Revision:  
ISSUED FOR BID  
02/01/2021  
BID ADDENDUM  
02/01/2021  
02/01/2021

Alterations to School District Facilities

Phase Two

Peekskill City School District  
Peekskill, NY

Drawing Title : LOWER LEVEL DRAINAGE PLAN  
Drawing Number : PP 301  
Date : October 2, 2020  
Drawn by : DAK

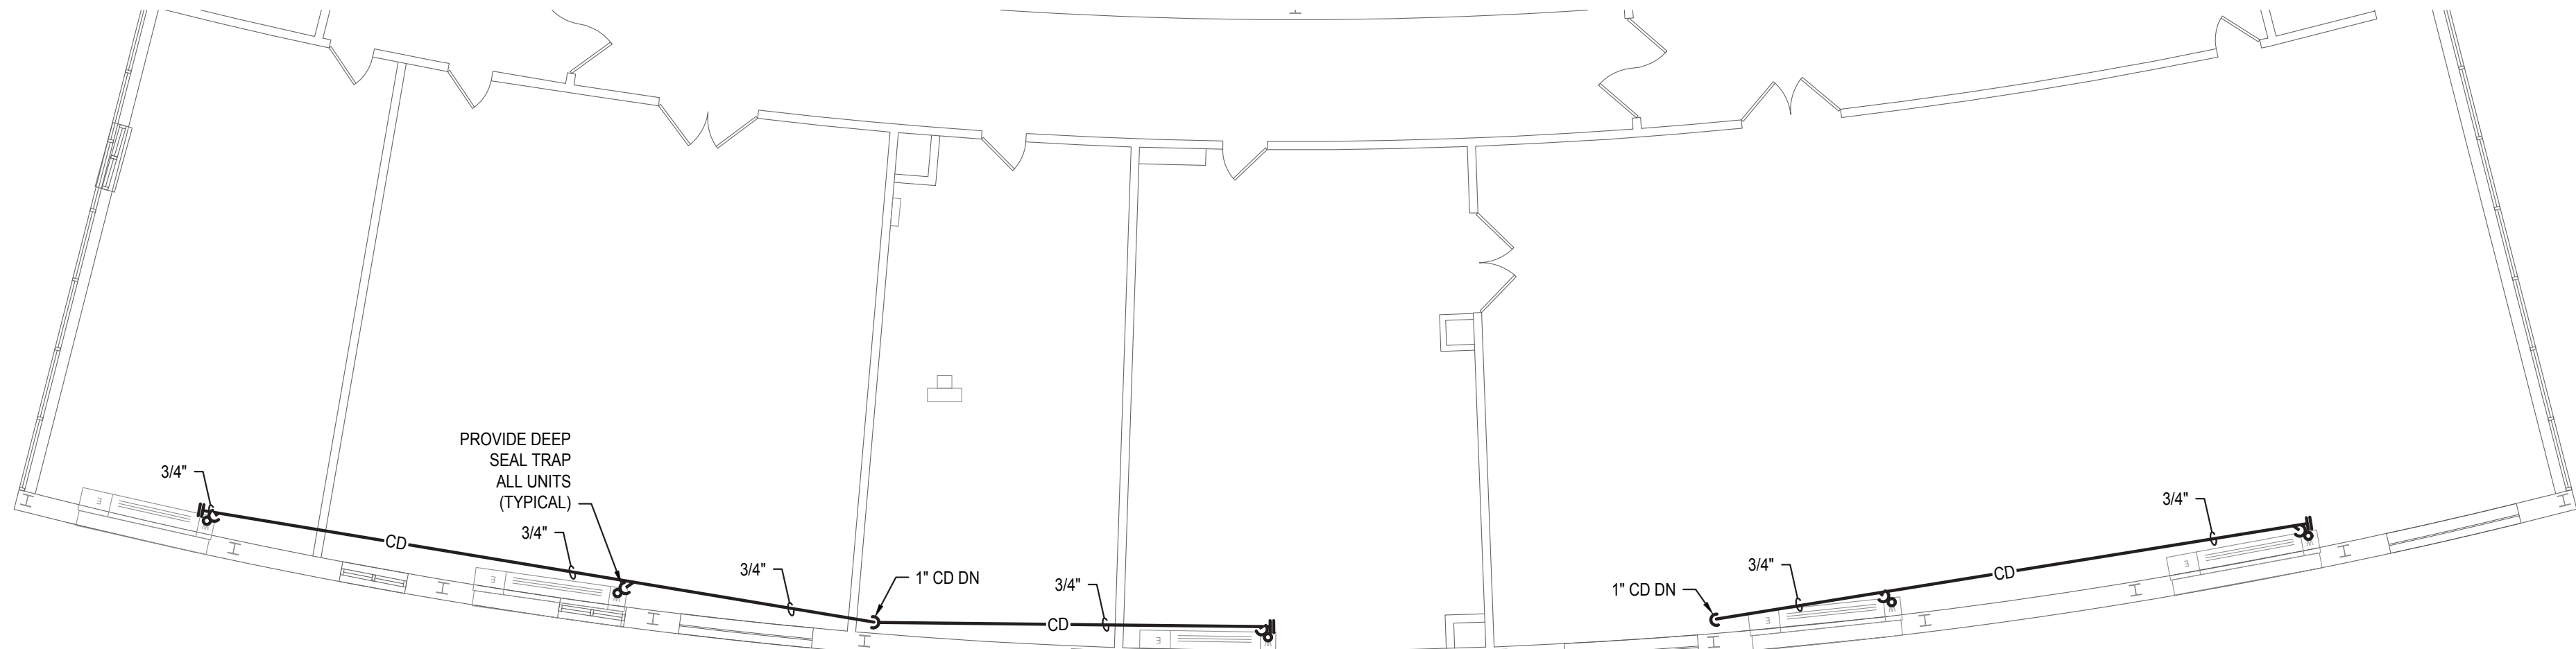
ALL WORK REQUIRED FOR THE AC DRAINS FOR THESE UNITS SHALL BE A PART OF ALTERNATE #2-P
